CITY OF FORT LAUDERDALE

CASE COMMENT REPORT

CASE NO. UDP-S25038

CASE	UDP-S25038
PROJECT NAME	Manor at Cypress Creek
APPLICATION TYPE	Site Plan Level II
APPROVAL LEVEL	City Commission
REQUEST	Design Deviation Request to the Uptown Master Plan Standards for 422 Multifamily Development with an Associated Parking Reduction in the Uptown Project Area
APPLICANT	CPN West, LLC. and F Land, LLC.
AGENT	Barbara A. Hall, Greenberg Traurig
PROPERTY ADDRESS	6700 N Andrews Avenue
ABBREVIATED LEGAL DESCRIPTION	Reflections 119-46 B Par A
ZONING DISTRICT	Uptown Urban Village Northeast (UUV-NE) District
LAND USE	Uptown Urban Village Transit Oriented Development
COMMISSION DISTRICT	1 – John Herbst
NEIGHBORHOOD ASSOCIATION	N/A
SUBMITTED	October 24, 2025
COMPLETENESS ISSUED	October 31, 2025
STATE STATUTE 166.033 EXPIRATION	February 28, 2026 (120 Days)
CASE PLANNER	Michael P. Ferrera, Urban Planner II

Architectural Design

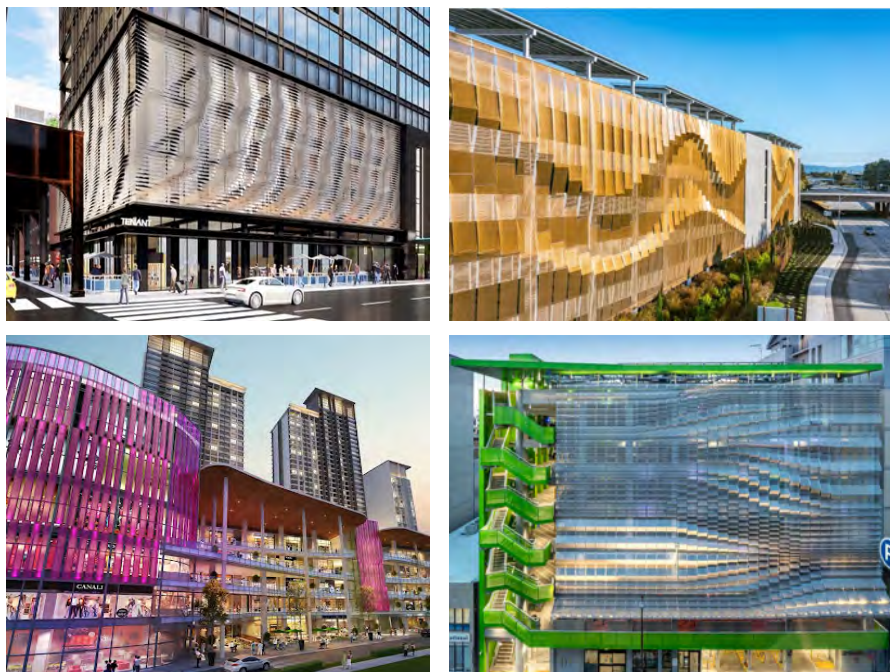
9. As proposed, the project does not meet the overall design intent for the Uptown area for an urban village that promotes a mix of uses, quality building design, improves connectivity and mobility in the area, emphasizes the pedestrian experience, and results in a transit-supportive built environment. Revisions are necessary to better align the project with the overall design intent which include the

following: (1) site layout, (2) park space, and (3) building design. The site layout with the building internalized centered on the parcel with retention on either side does not provide for meaningful interaction with adjacent existing uses. In addition, the parking along the south side prevents the opportunity to create an enhanced pedestrian experience leading to the pedestrian trails and this parking also generates unnecessary conflicts with both the project's operations and those of the adjacent Marriott Hotel, particularly regarding ingress/egress and back-out parking maneuvers. The areas identified as pocket parks lacks connection to the private amenities; pool area and courtyard, which are largely enclosed thereby restricting natural light, air circulation, and visibility. Furthermore, the building mass is large with very little design mitigation for increased floorplate. Additional articulation is needed throughout the structure, including extending corner treatments beyond the existing roofline, incorporating more substantial wall offsets, varied roofline heights, and a broader set of architectural elements to break up the massing and strengthen visual interest. Images below provide examples on design.

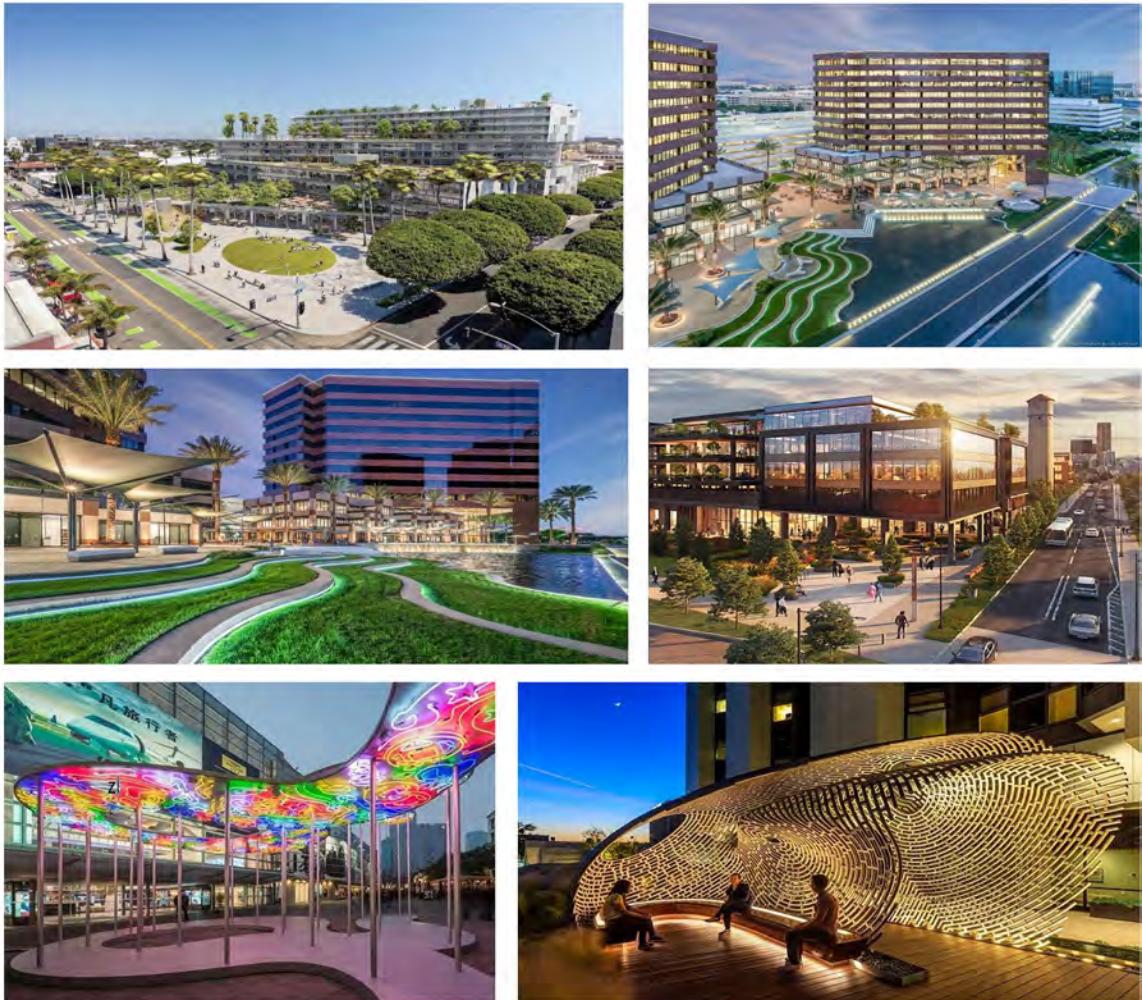
b. Pursuant to Section 47-37B.6.I, Parking Structures. As proposed, there is only one material for the garage screening labeled as "screening panel", which does not meet this section of code. The visual impact of the project compared to existing conditions today needs to be mitigated through exceptional screening solutions. Such solutions should break-up the garage façades with variation in form, material diversification, enhanced corner design, or building illumination. In addition, provide elevations that demonstrate that 50% of the façade is screening per code. See below for examples of screening materials.
